Rezoning Application: RZ-PD 25-0579

**Hillsborough
County Florida**

Development Services Department

APPLICATION NUMBER: PD 25-0579

Figure 2: Typical Section

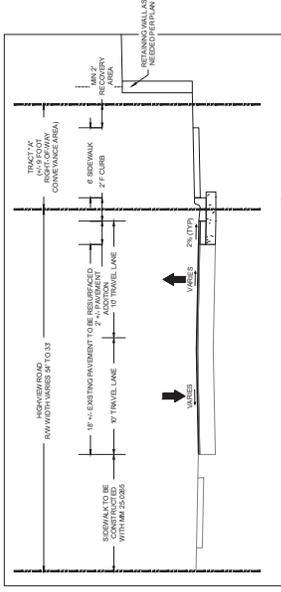
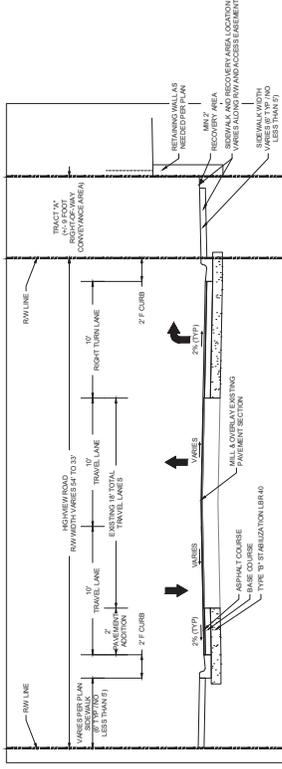
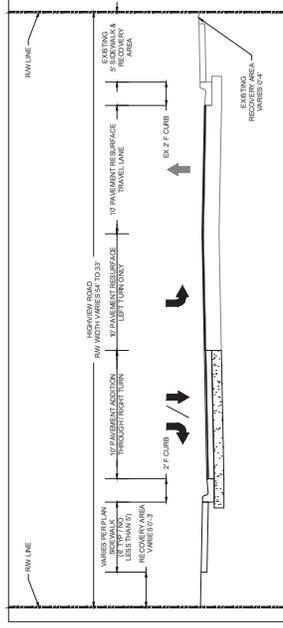
1. The request is to provide 10-foot travel lanes instead of the 11-foot travel lanes with 7-foot buffered bicycle lanes. According to the Florida Green Book, on a suburban roadway where the speed limit is between 25 and 35 mph, 10-foot travel lanes may be used. The post speed limit on Highview Road is 25 mph.

- 2. A 9-foot area (Tract A) will be dedicated to accommodate the F type curb, sidewalk and a 2-foot strip behind the sidewalk.
- 3. A 6-foot sidewalk will be provided along the east side of Highview Road at the back of curb. On the west side of Highview Road, a sidewalk will be constructed as part of MM 25-0265.

87878787878
TYPICAL SECTIONS
SHEET NO. C1

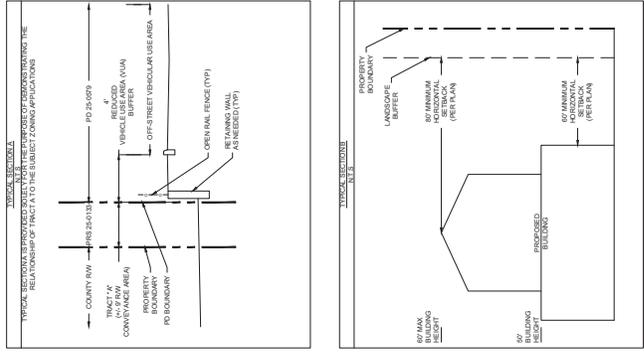
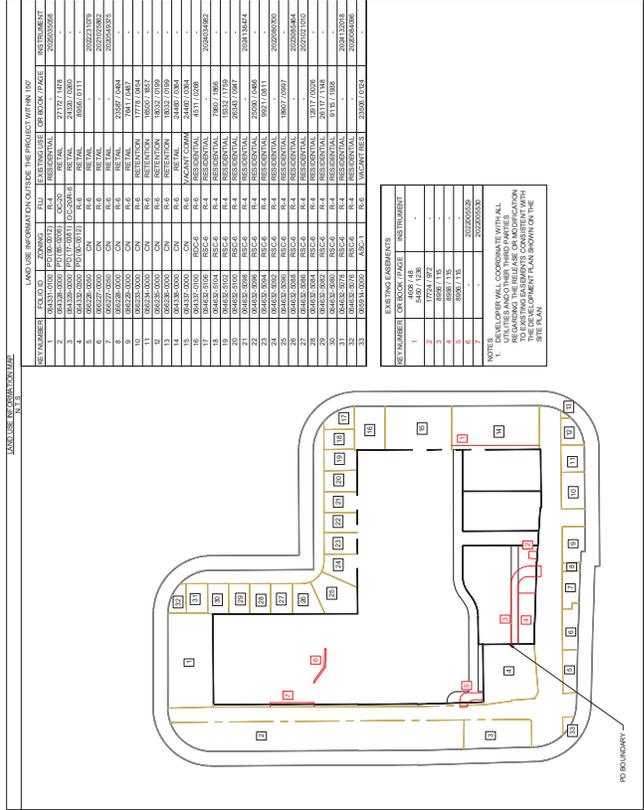
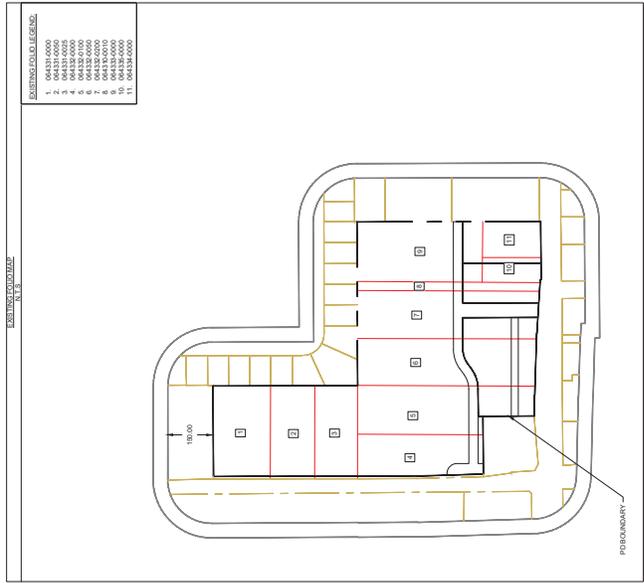
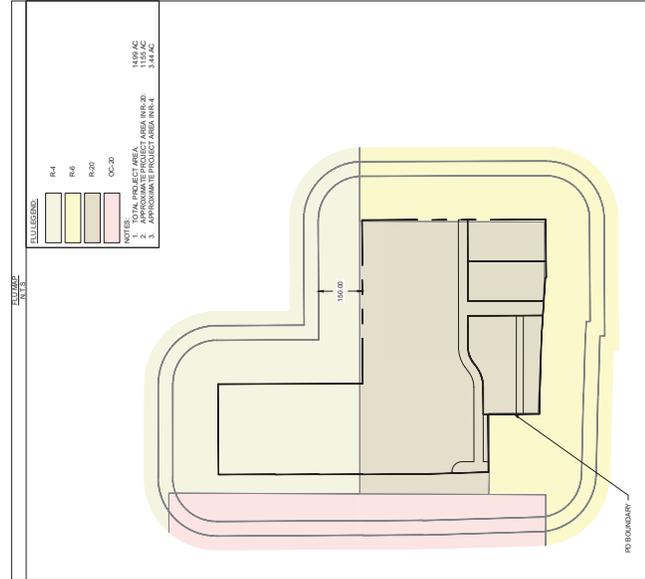
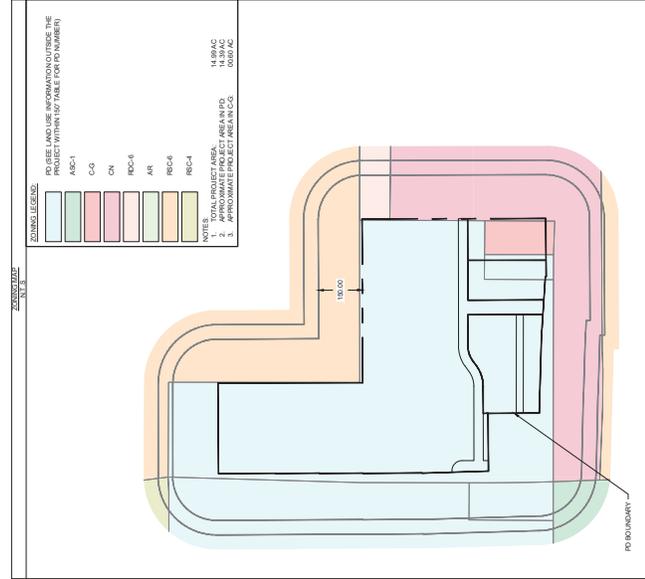
1. The request is to provide 10-foot travel lanes instead of the 11-foot travel lanes with 7-foot buffered bicycle lanes. According to the Florida Green Book, on a suburban roadway where the speed limit is between 25 and 35 mph, 10-foot travel lanes may be used. The post speed limit on Highview Road is 25 mph.

2. Provide a 10-foot wide, 95-foot-long northbound right turn lane at the project driveway. The length includes a 50-foot taper. According to the Florida Green Book, on a suburban roadway where the speed limit is between 25 and 35 mph, 10-foot auxiliary lanes may be used. The post speed limit on Highview Road is 25 mph.

Figure 2: Typical Section

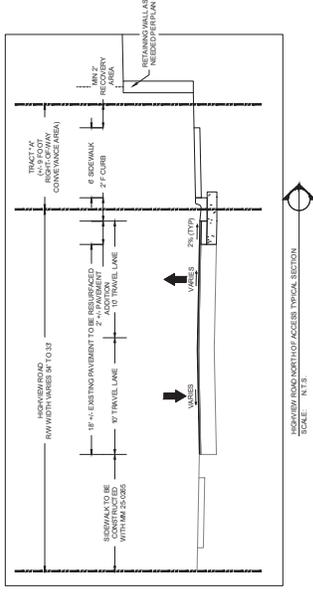
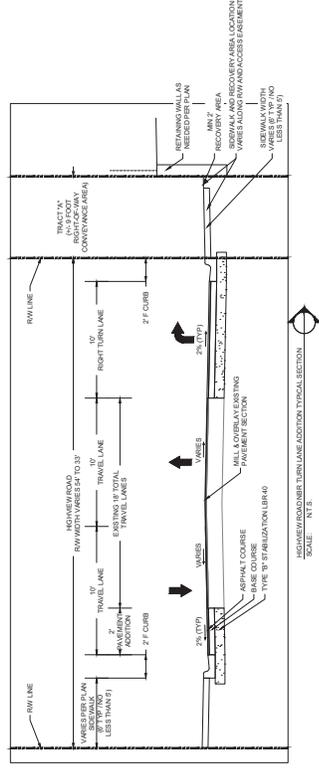
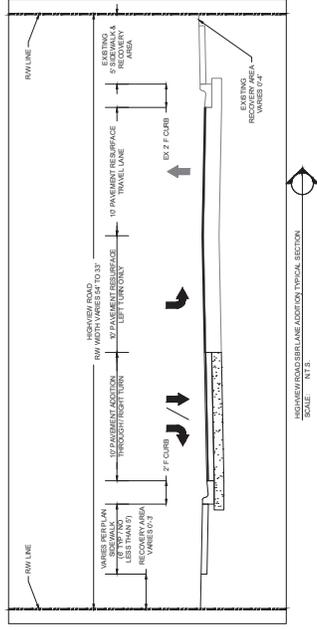
1. The request is to provide 10-foot travel lanes instead of the 11-foot travel lanes with 7-foot buffered bicycle lanes. According to the Florida Green Book, on a suburban roadway where the speed limit is between 25 and 35 mph, 10-foot travel lanes may be used. The post speed limit on Highview Road is 25 mph.

2. A 9-foot area (Tract A) will be dedicated to accommodate the F type curb, sidewalk and a 2-foot strip behind the sidewalk.
3. A 6-foot sidewalk will be provided along the east side of Highview Road at the back of curb. On the west side of Highview Road, a sidewalk will be constructed as part of MM 25-0265.

DESIGN EXCEPTION – HIGHVIEW SOUTH SECTION

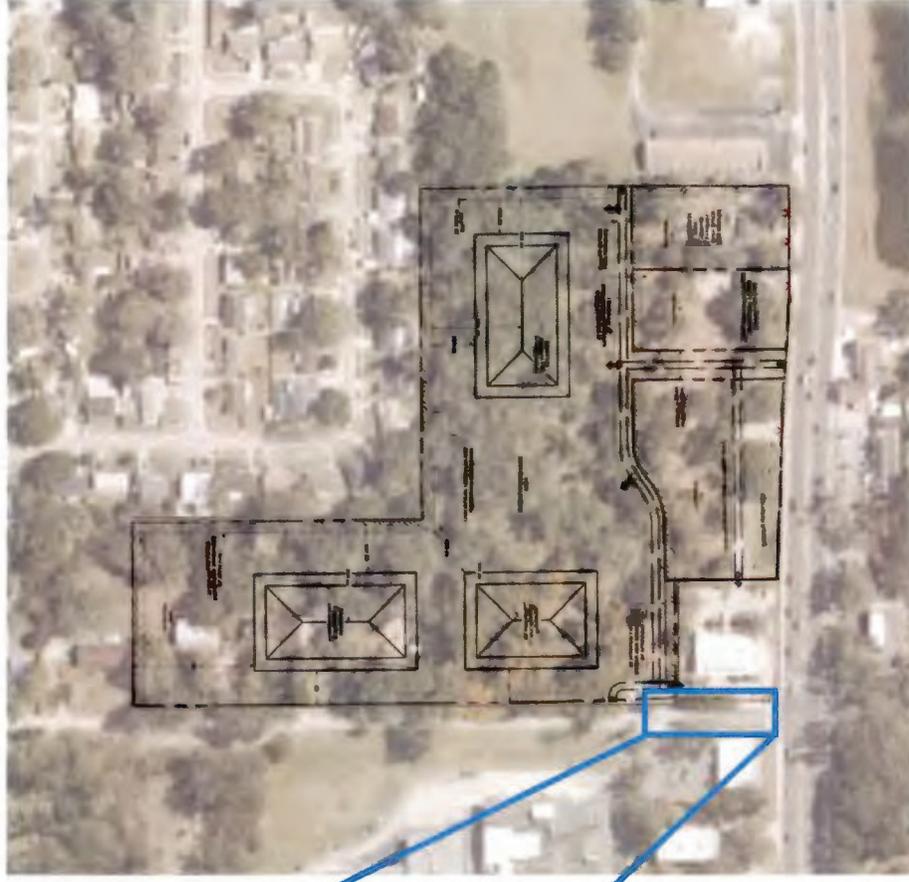
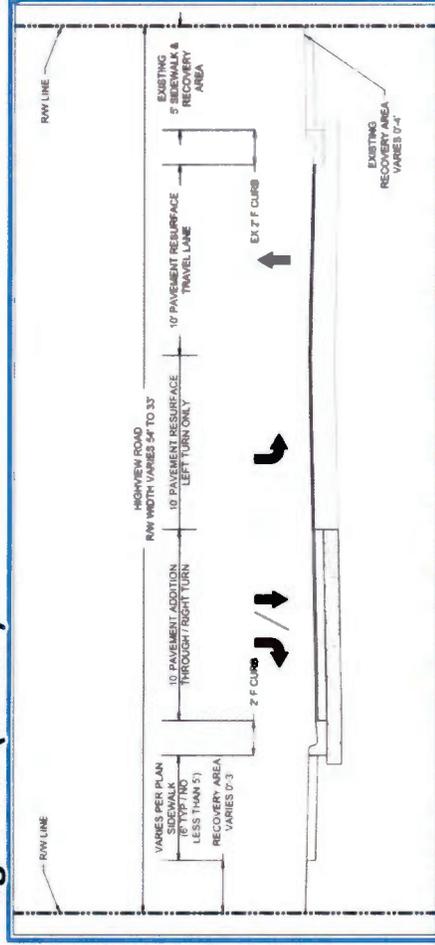
- Widen through lanes from 9' to 10'
- Existing through lane converted to southbound left turn lane
- New 135' long (including 50' taper) 10' wide southbound shared right turn/ through lane
- 6' (min.) sidewalk along west side, subject to available right-of-way

DESIGN EXCEPTION – HIGHVIEW ACCESS SECTION

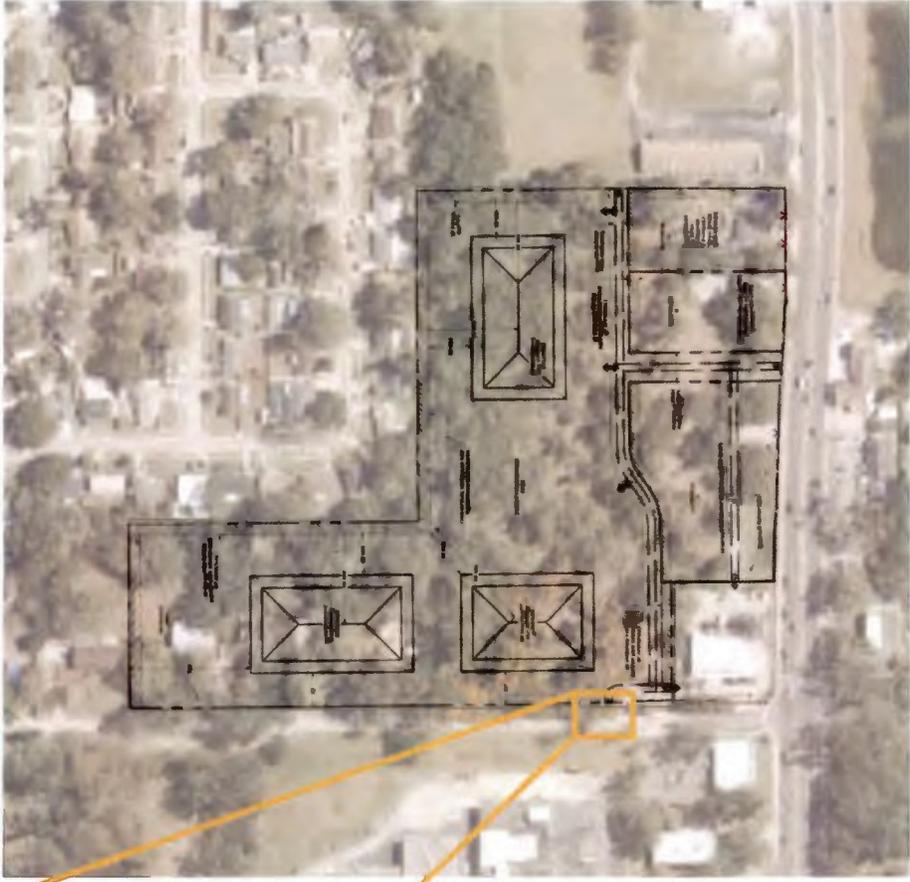
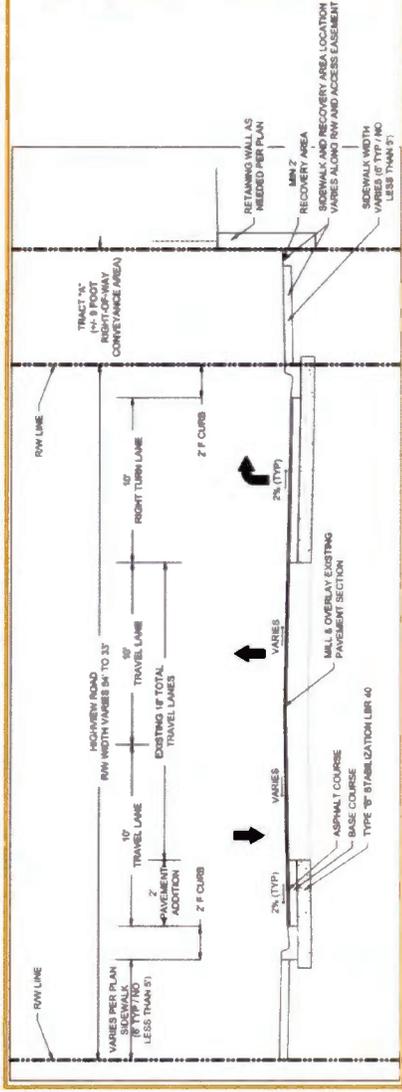
- Widen through lanes from 9' to 10' with Type F curb on the east side of the roadway
- New 95' long (including 50' taper) 10' wide northbound right turn lane at project driveway
- 6' (min.) sidewalk along west side subject to available right-of-way

DESIGN EXCEPTION – HIGHVIEW NORTH

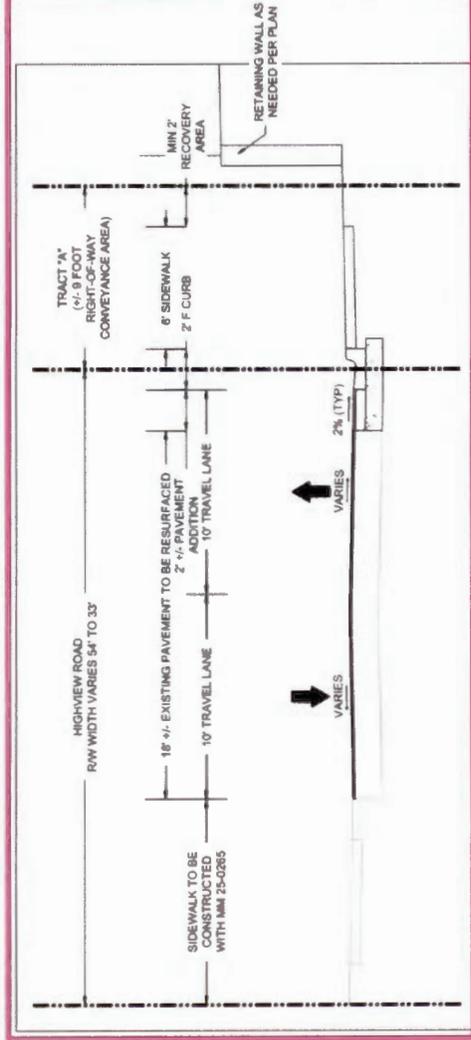
- Dedication of 9' "Tract A"
- Widen through lanes from 9' to 10' with Type F curb on the east side of the roadway
- 6' (min.) sidewalk along east side

Highview Rd between MLK and Clay Pit Rd.

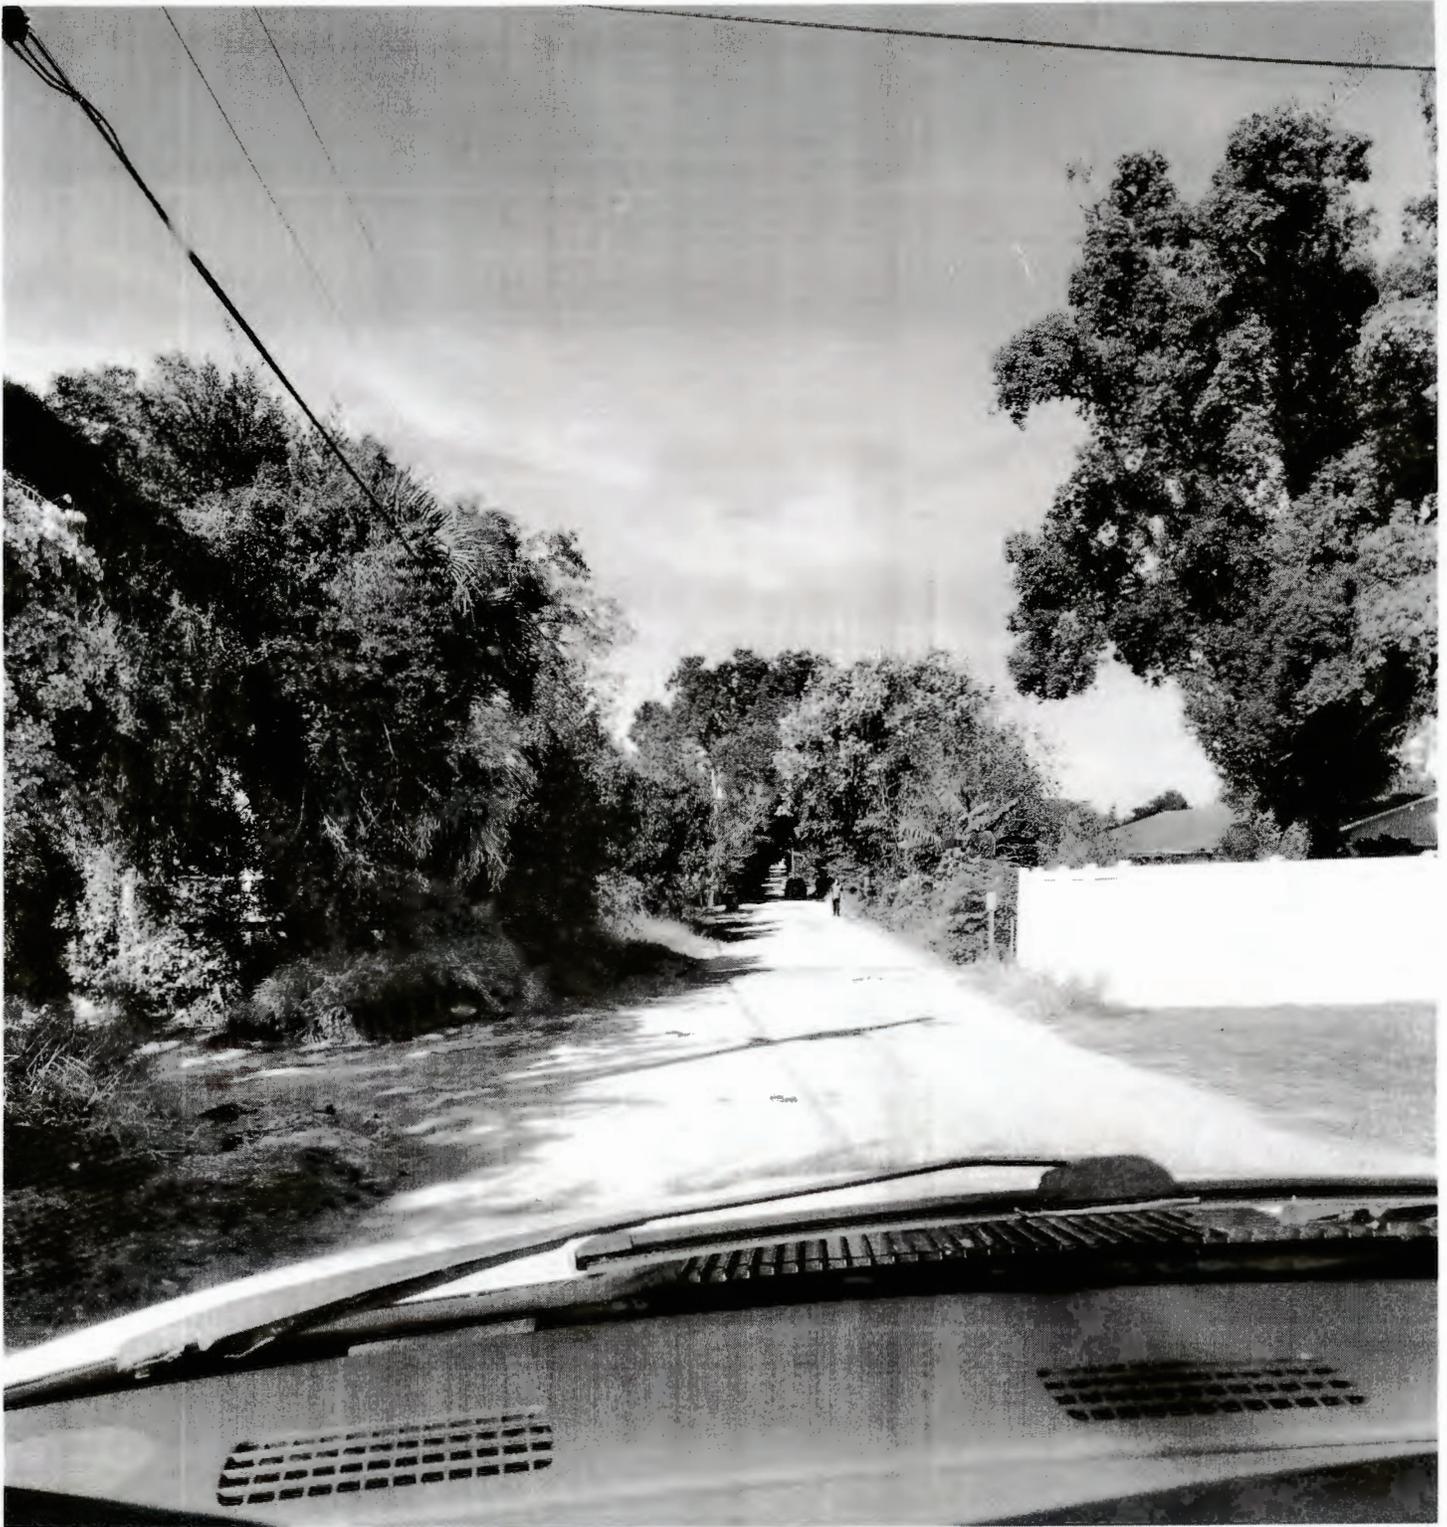
Walmart will be accessing this road.
Apartments will be accessing this road
as well. Curbs are only developed to this
point and no sidewalks beyond this point
until you get to rec center
